802.3as Frame Expansion

Changes to Clause 4

Glenn Parsons
Nortel Networks

January 2005

802.1Q Tagged Frame

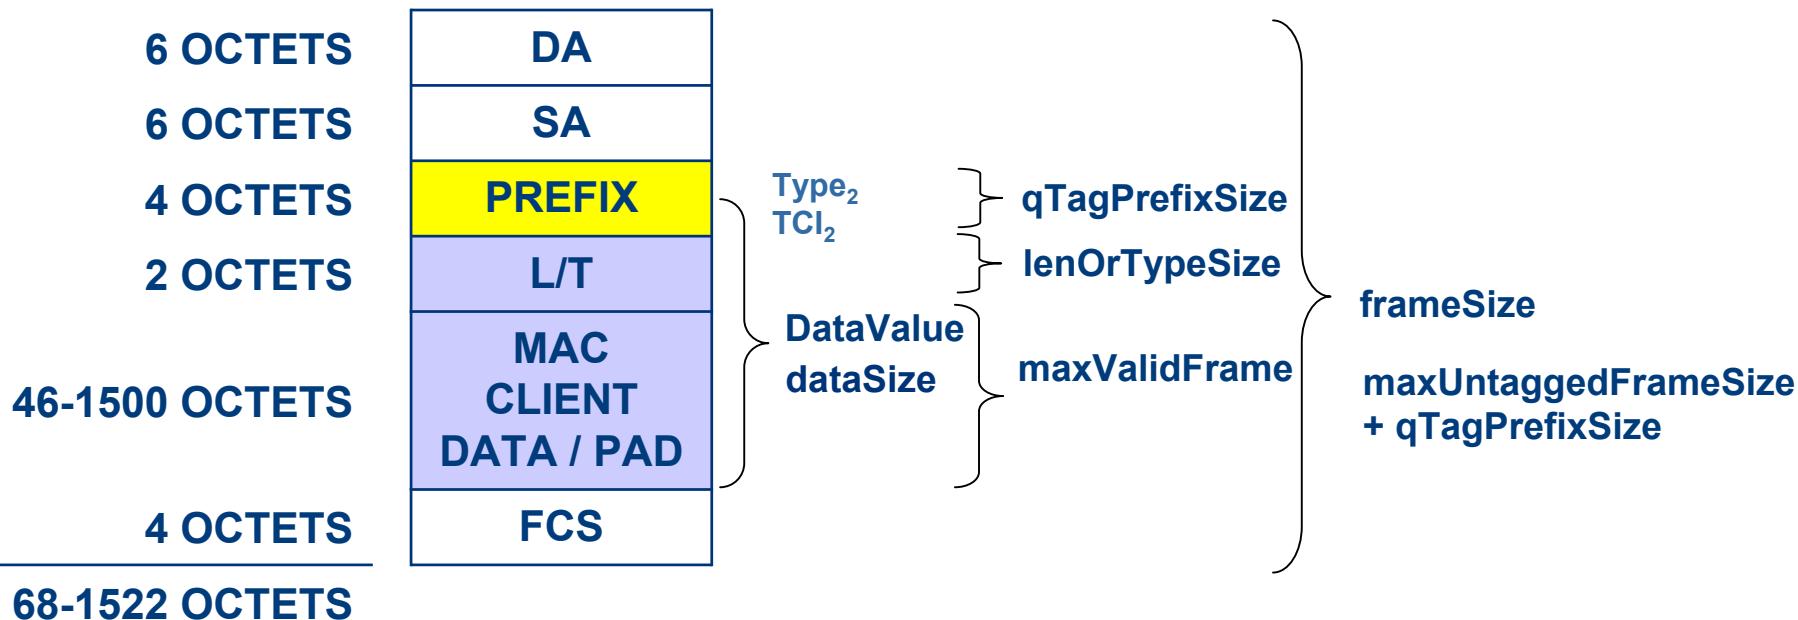
Constants - 802.3-2002

Constants - 802.3as

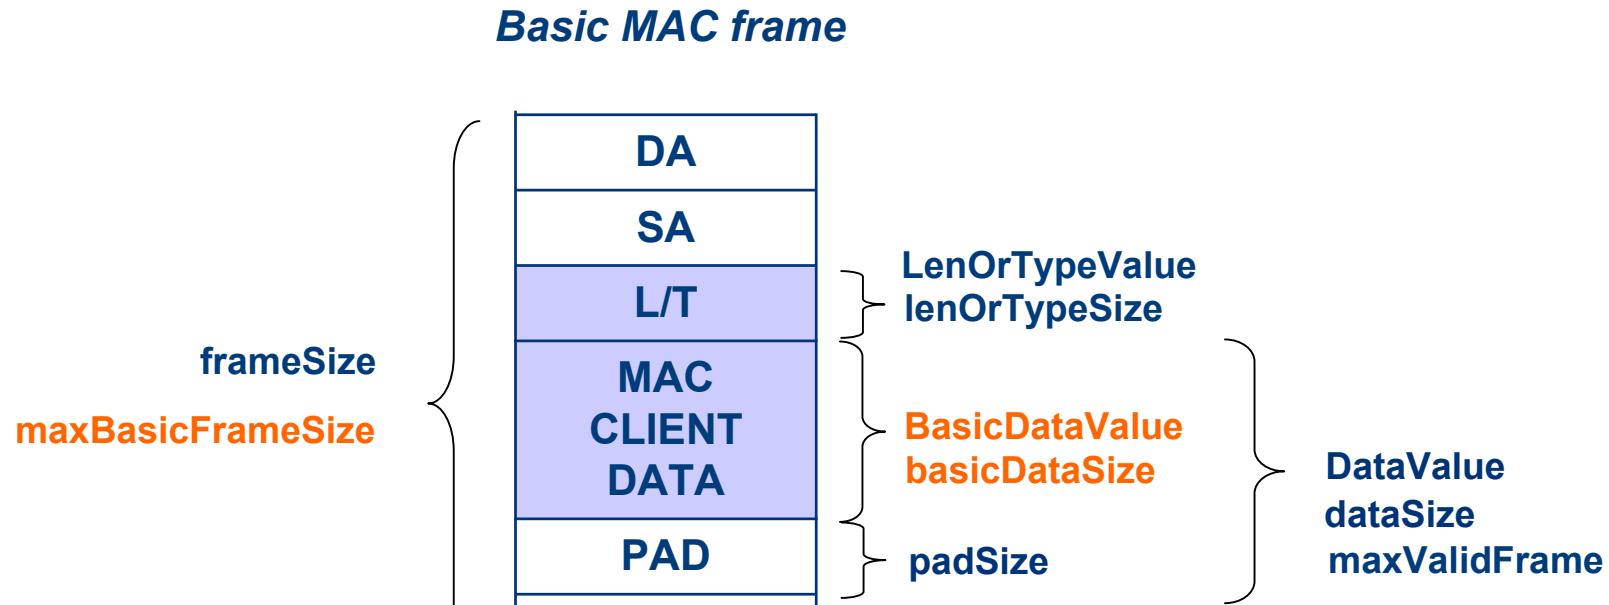
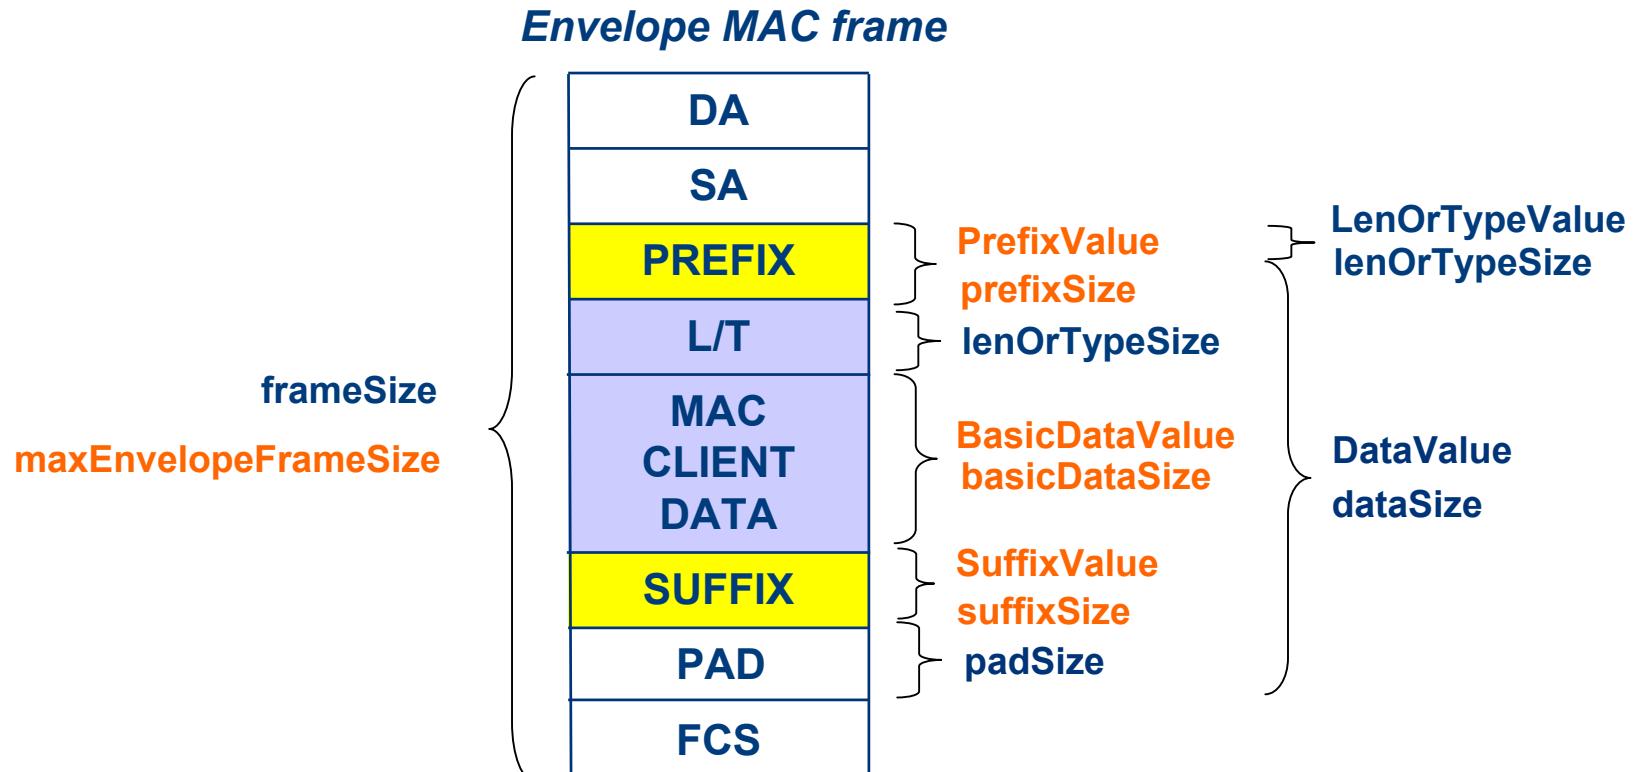
Envelope MAC frame

$$\text{maxValidFrame} = \text{basicDataSize} + \text{padSize}$$
